Redrawn by: Danjovic 2021

TITLE: MC-10 Schematics	
Document Number:	REV: C
Date: 04/10/2021 11:21:45	Sheet: 1/1

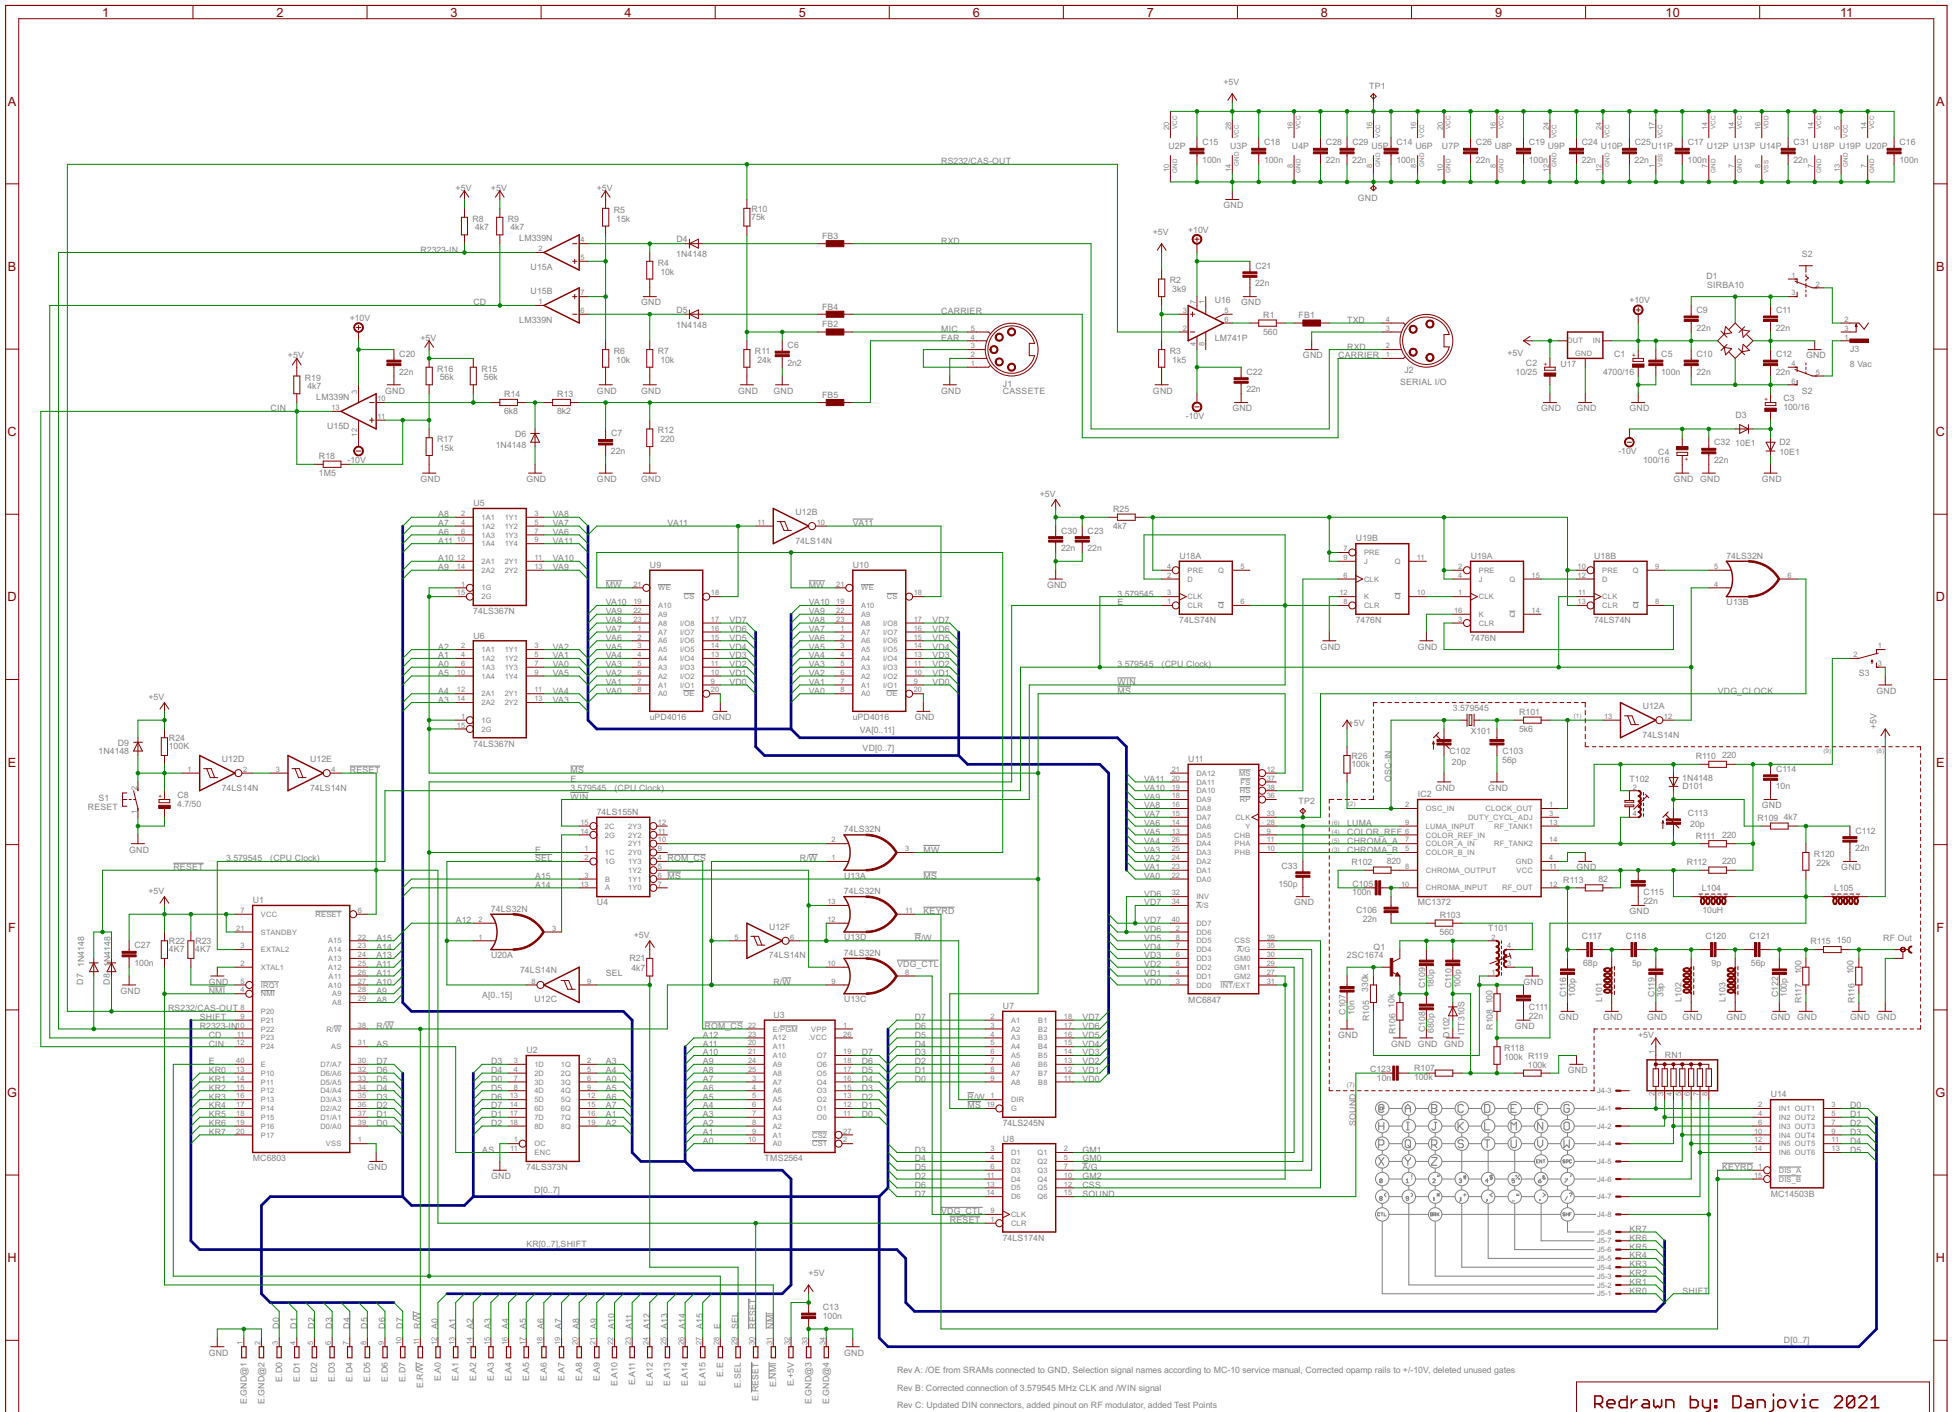
Rev A: /OE from SRAMs connected to GND, Selection signal names according to MC-10 service manual, Corrected opamp rails to +/-10V, deleted unused gates

Rev B: Corrected connection of 3.579545 MHz CLK and /WIN signal

Rev C: Updated DIN connectors, added pinout on RF modulator, added Test Points
